SPB Number: 2023.0306

FINISH UPDATES

STANDARD PLAN **BULLETIN** NOTICE RaceTrac Engineering and Construction Division

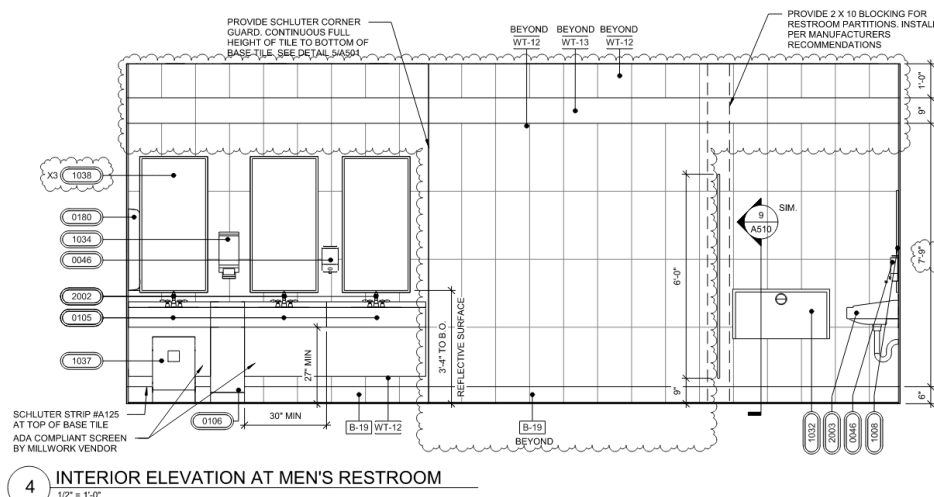
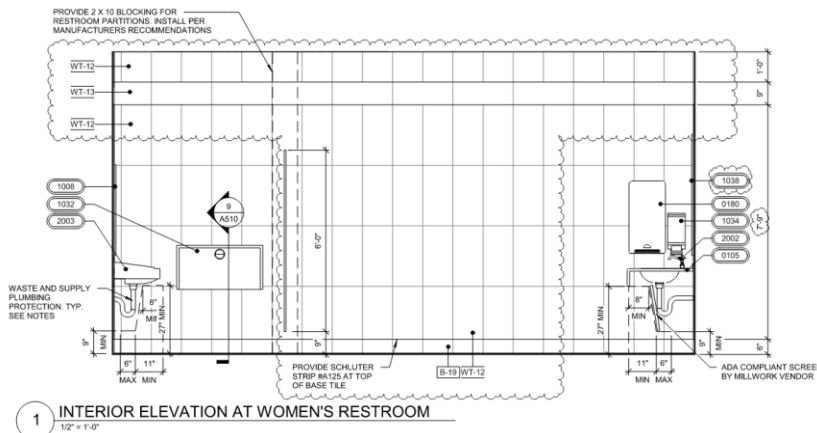
- RESTROOM UPDATES:** Replaced floor tile FT-14 in the Men's and Women's restroom with floor tile FT-13. Removed the full height wall tile WT-13 on either side of the hand sinks and at the center of the restrooms. Removed wall tile WT-14. Removed the soffit above the hand sinks and adjusted the light fixtures to be on the main ceiling.
